Lower Lee (Cork City) Flood Relief Scheme (Drainage Scheme)

Exhibition Report

Office of Public Works

Issue to website | 5 December 2017

Figure 24: West of City River Access Points

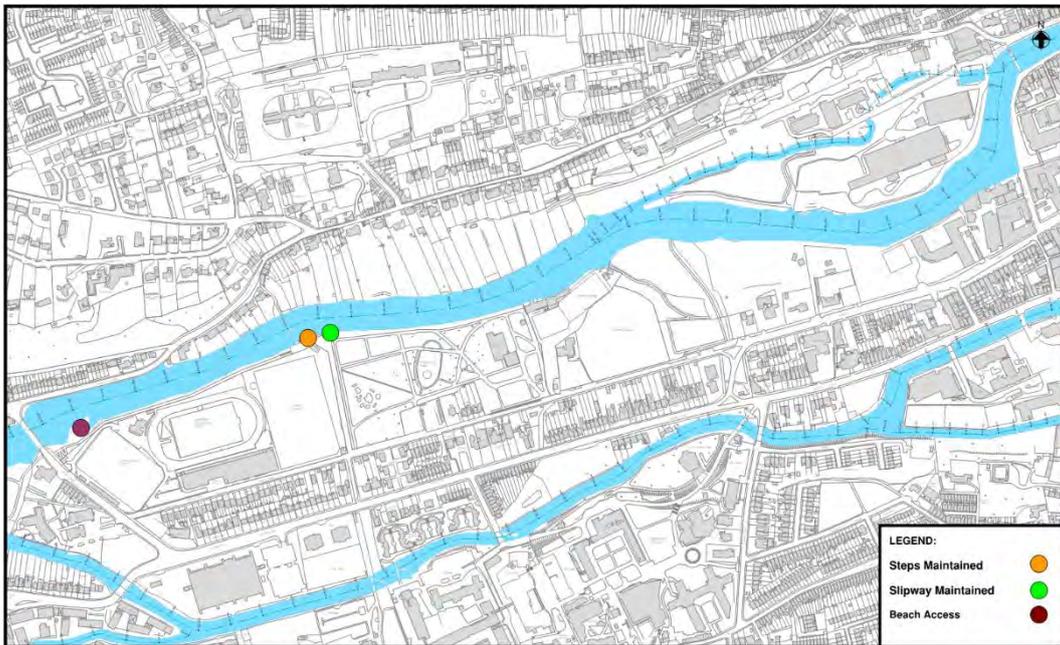
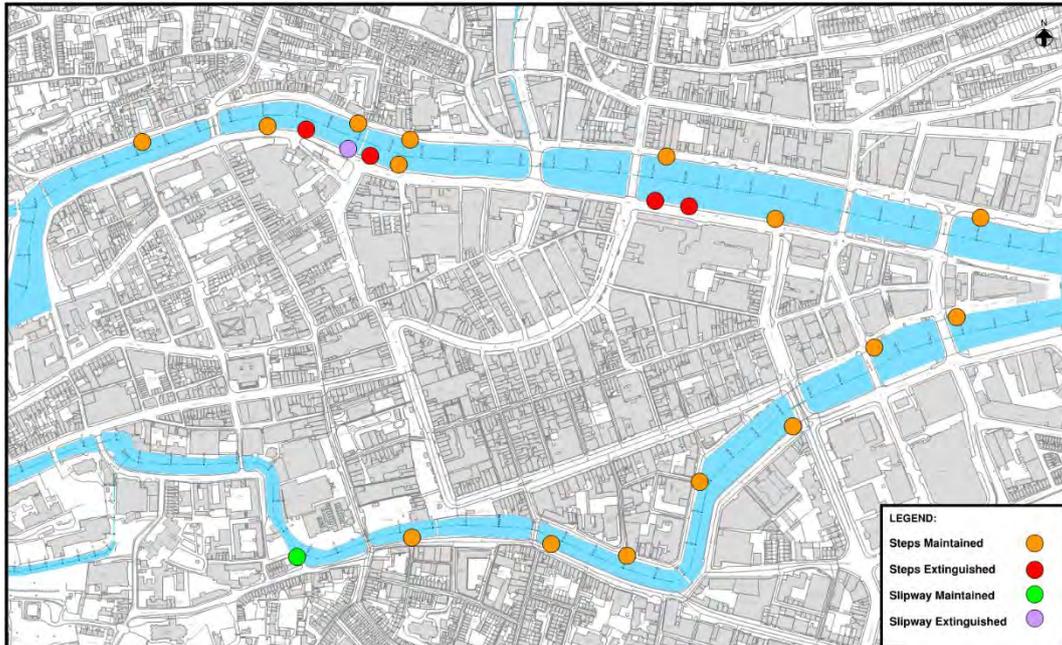
Figure 24 & Figure 25 below identify the exhibited alterations to access routes along both the North and South Channel.

In the exhibition documentation, it is acknowledged that there were some errors or ambiguities, and as a result it was not clear what was proposed at a small number of these access points.

Since exhibition stage, a number of submissions have been received and in conjunction with river user groups it is proposed to increase and improve the number and type of access routes to the river. Details of the proposed changes are set out in Section 9.2 of this report.

Figure 27: Section of Exhibited Defence Solution along Mardyke Arena

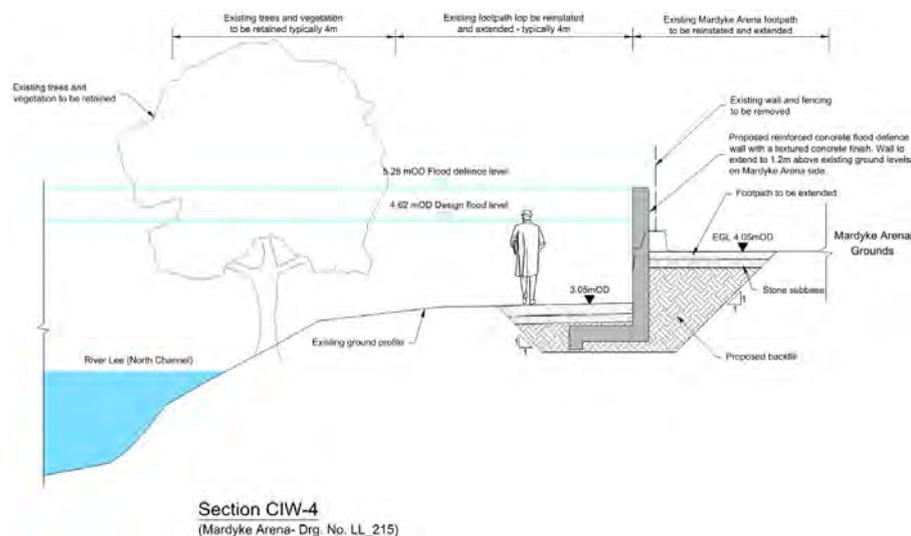
There are concerns that the riverside walkway between Thomas Davis Bridge and Daly's Bridge could have increased potential for security issues / antisocial behaviour due to the increased height of the wall between the walkway and the Mardyke Arena. Views were expressed that the pathway currently benefits from a degree of "passive surveillance" from the Mardyke Arena, which would be removed by the proposed scheme as exhibited. This walkway is currently gated and locked at night, which will continue in the future. Figure 27 below shows a typical section through the exhibited solution at this location.

This issue was considered in detail by the Steering Group and it is now proposed to amend the scheme to raise the existing footpath on the wet side of the defence to ensure that passive surveillance will be maintained. Refer to Section 9.5 for further detail.

Figure 39: Revised Photomontage of Grenville Place depicting accurate parapet heights

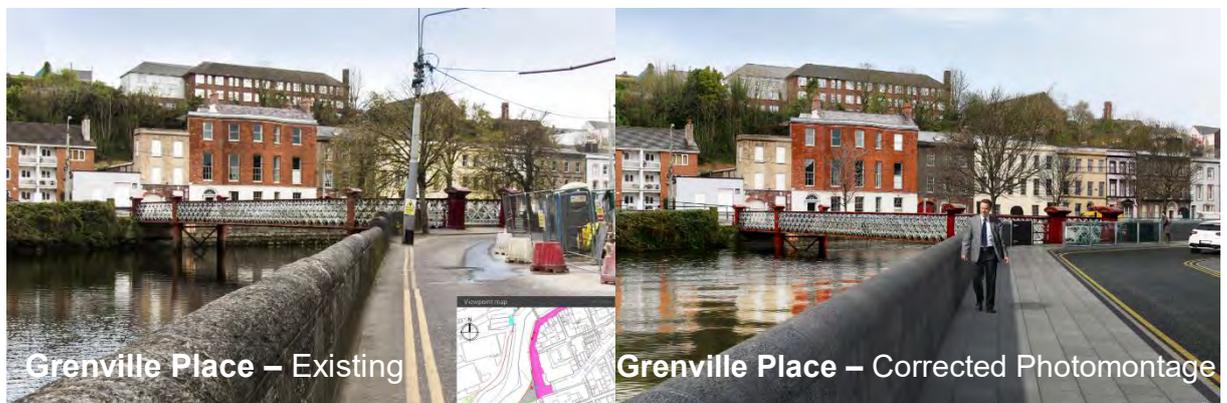
The image therefore shows a proposed view taken at knee height instead of at eye line height. The incorrect image is shown in Figure 37.

A corrected photomontage was subsequently prepared and is shown in Figure 38. This correct image is taken at eye line level for the proposed scenario and illustrates that the relative parapet height is not dissimilar to at present and will ensure that river views will be retained.

Figure 39 above more accurately reflects the proposed solution at this area. It is clear that parapet heights are kept to a maximum height of 1.2metres. This, coupled with the introduction of a footpath along the river edge will increase the ease at which pedestrians can view the river and thus increase the connection to the Lee in this historic location.

Figure 41: Image showing conveyance route adjacent to Grenville Place and indicative extent of proposed plaza

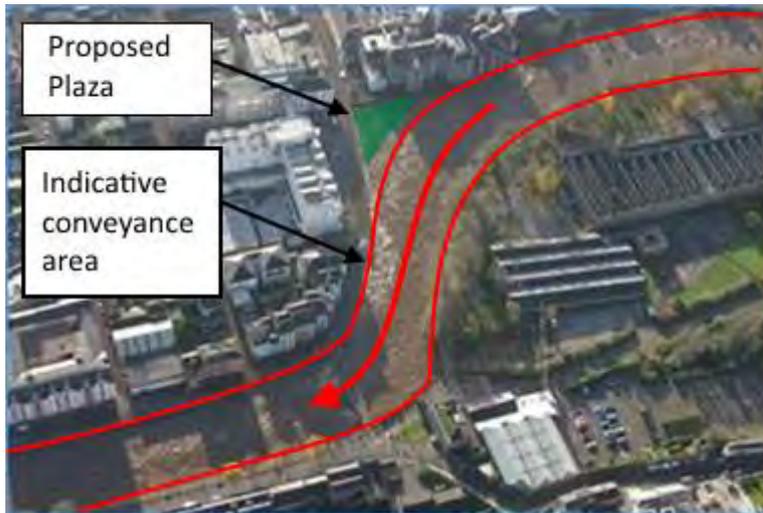
Concerns were also raised in relation to potential increase in river levels due to the construction of the plaza. This is not the case, as the proposed wall alignment has been subject to detailed hydraulic modelling to ensure that it does not significantly reduce the conveyance capacity of the channel at this location. While the proposed wall will involve reclamation of part of the existing river channel, it has been determined that this area currently does not contribute significantly to conveyance capacity. This has been separately verified through observations of past flood events, which showed large zones of slow moving water and eddy currents within the area to be reclaimed. Figure 41 below indicates the approximate extent of the effective conveyance area within this reach.

Figure 45: Existing & Exhibited Section along North Mall

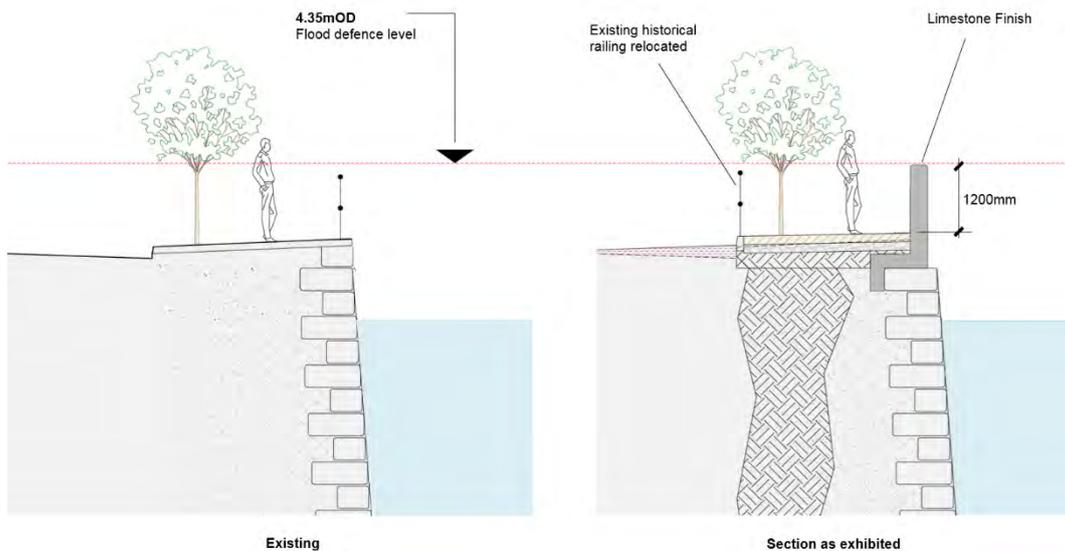
The originally exhibited solution proposed replacement of the existing historic quay-side railing with a 1.2m parapet wall is shown in Figure 18 below.

The solution as shown in Figure 45 & Figure 46 would limit the height of the parapet wall to no higher than normal minimum guarding height (1.2m). The proposed parapet wall was exhibited as a fair faced finished concrete. However, it was recognised that the actual finish would need further consideration, particularly in light of comments received from the public and other key stakeholders.

Figure 47: Sullivan's Quay Existing vs. Exhibited

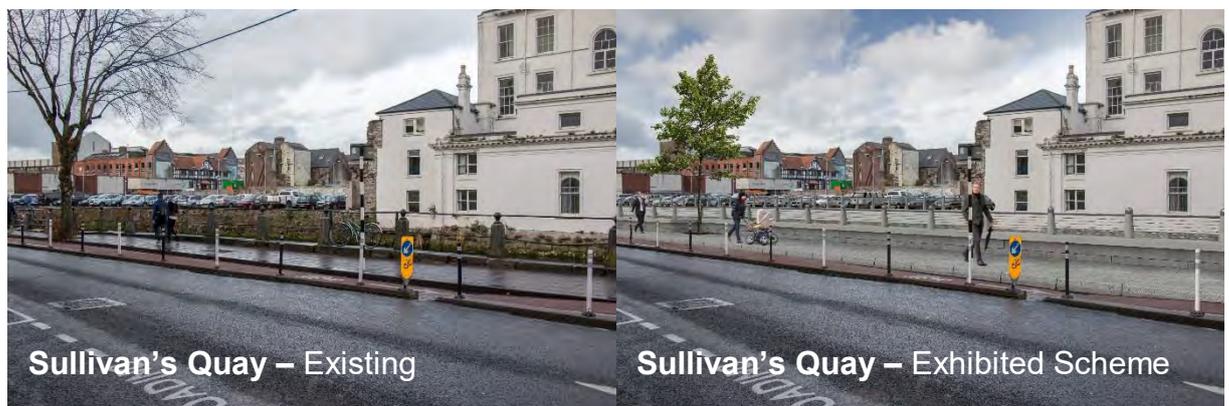
The originally exhibited solution along this stretch proposed replacing of the existing quay-side railing with a 300 - 600mm parapet wall with new railing on top, finished with cut limestone cladding to match the quay wall and parapet/quay walls on the opposite bank as shown in Figure 47 below. It was proposed to retain and relocate the existing historical railing to another suitable location in the vicinity.

Ultimately, following a review of the advantages and disadvantages, the various constraints, in particular the Health and Safety issues associated with the open existing historic railings (but also trees, traffic, parking, constructability, costs, etc.), and in consultation with the Steering Group, it was agreed to progress based on the option as shown in Figure 47.

Figure 49: Photomontage of Exhibited Solution for rear of South Mall Properties

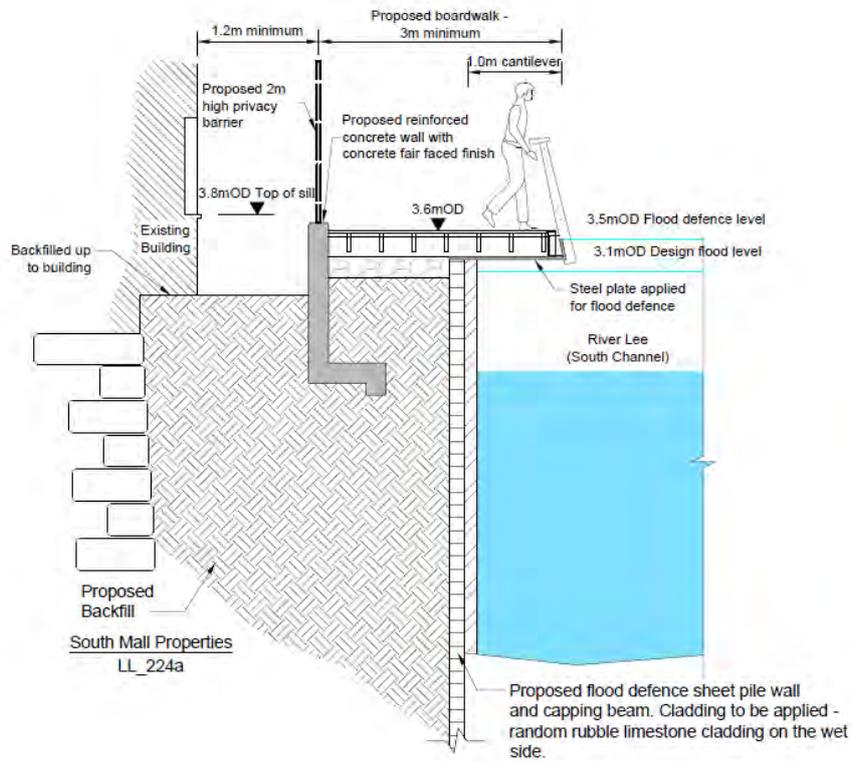
The exhibited solution is shown in Figure 48 and Figure 49 below.

It has also been decided to remove the boardwalk element from the scheme at South Mall properties given that it is not essential to the function of the flood defence scheme. However, the revised design will provide the flexibility for such a boardwalk to be constructed in the future, if appropriate.

Figure 54: Section Sketch of Proposed additional Lee Road defences

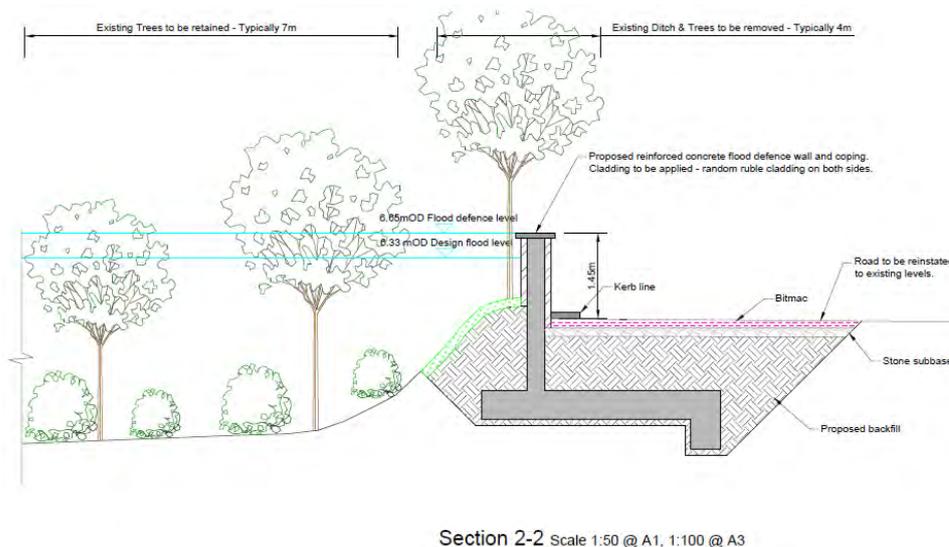
Refer to Figure 52 to Figure 54 and for plan and section sketches of the proposed additional Lee Road defences.

The OPW now proposes to protect the Lee Road from flooding and thus provide safe access for residents who rely on the road.

Figure 56: Section Sketch of Amended Defence at Mardyke Riverside Walkway

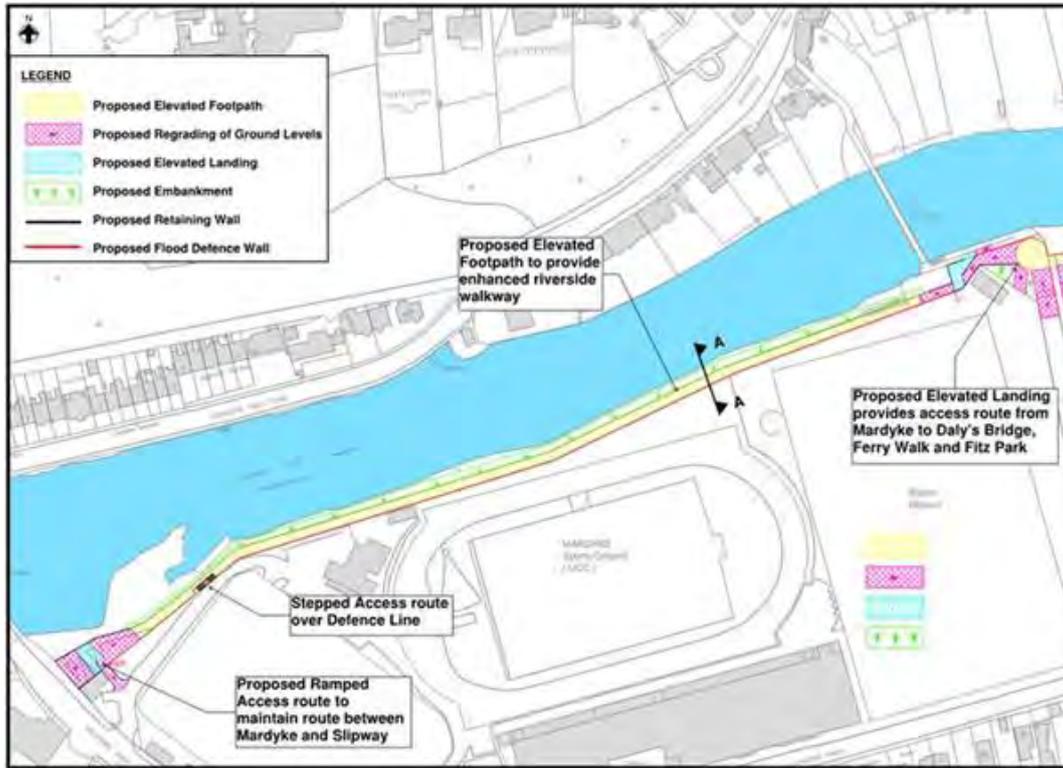
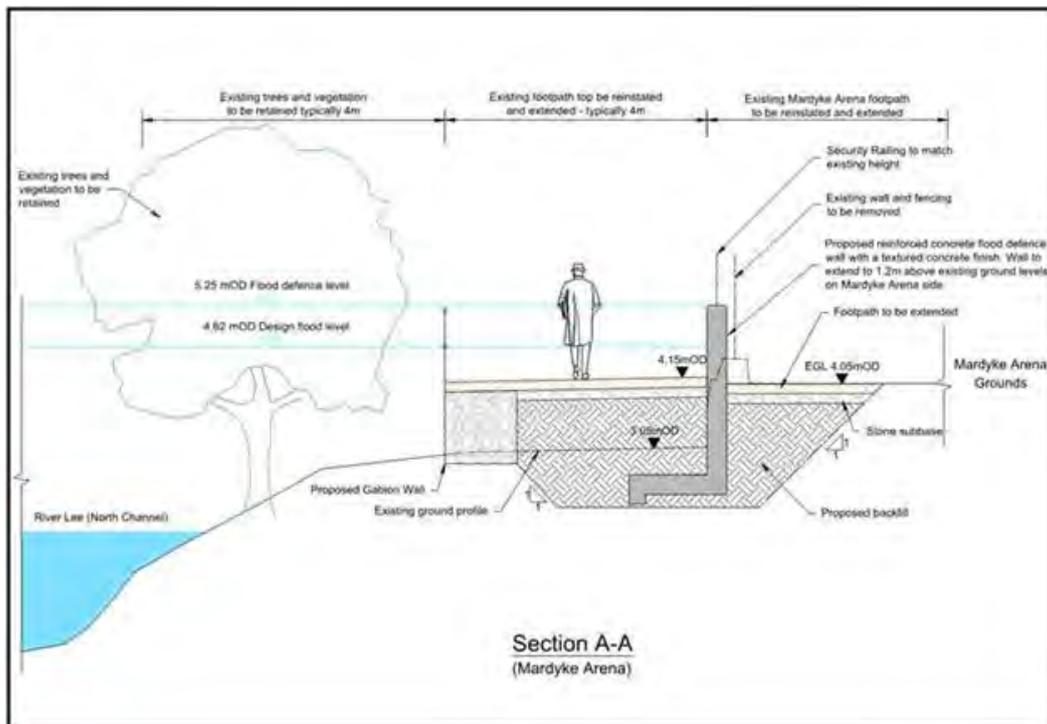
Figure 55 and Figure 56 below show the amended solution at this location. The decision to raise the footpath along the river to the north of the Mardyke arena will help to retain an open aspect to the walkway and help it benefit from a degree of passive surveillance.

While a low retaining wall and railing is shown on the northern edge of the proposed footpath (refer to Figure 56), in locations where more generous areas of riverbank are available, a graded earth edge will be provided instead. This would allow a more open and accessible relationship with the river and remove the need for protective railing (particularly important at the beach area and ramp towards the western end of the walkway).

Figure 58: 3D Section of Proposed Alternative Solution in flood scenario

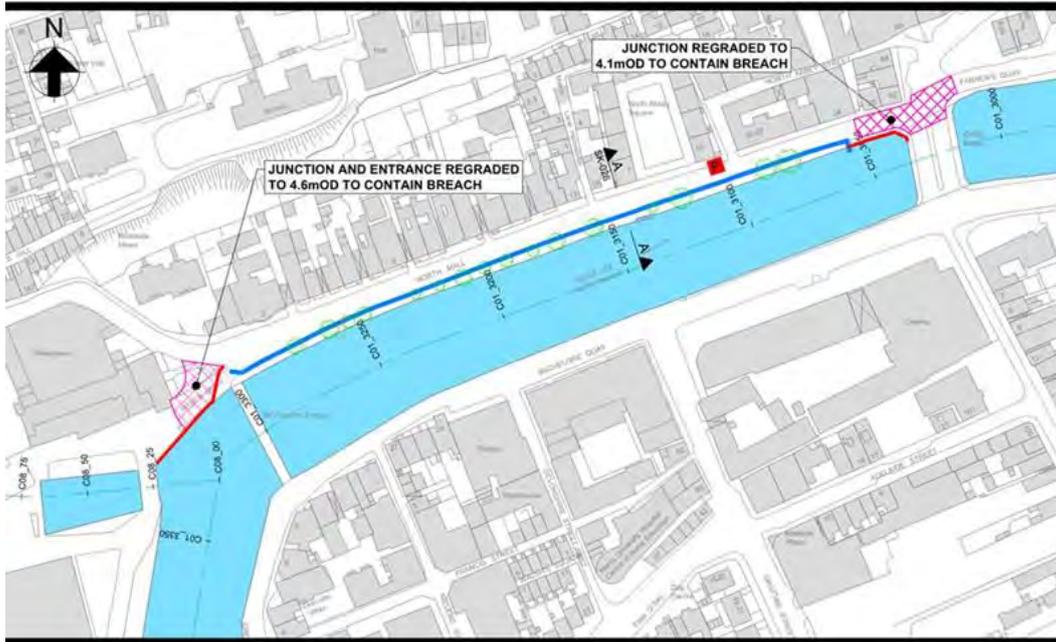
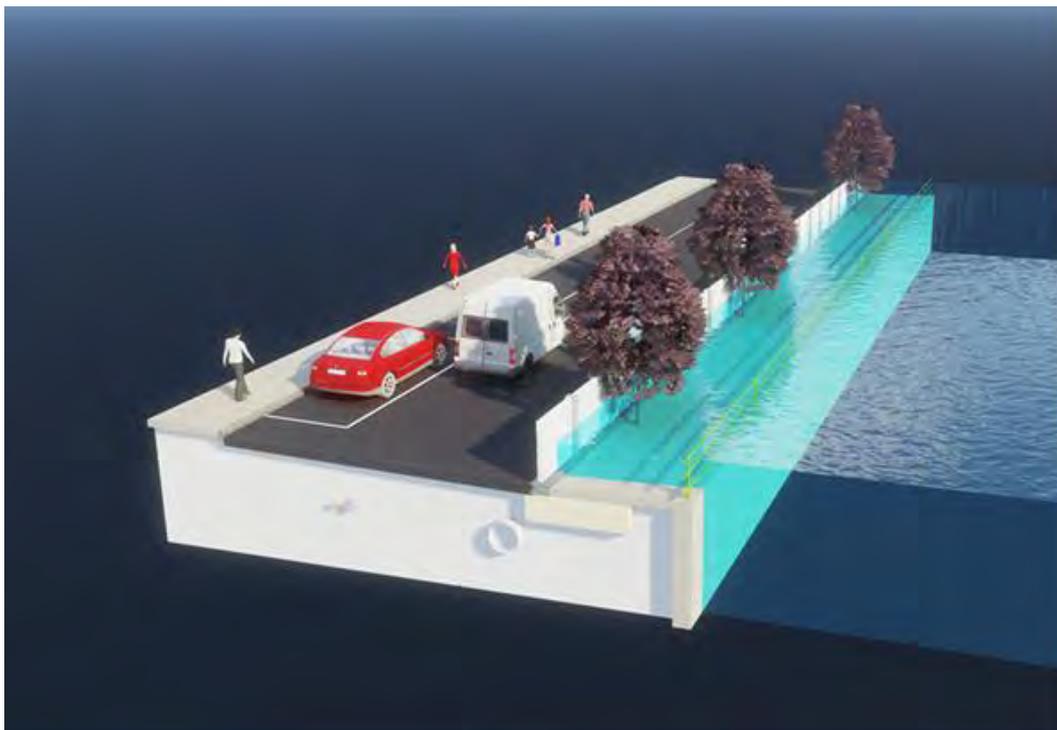
Following the public consultation process, the revised solution now proposed is shown below in Figure 57 and comprises:

It is felt that the revised solution as shown in Figure 58 and Figure 59 appropriately addresses stakeholder concerns, while balancing all of the constraints outlined in Section 7.4.
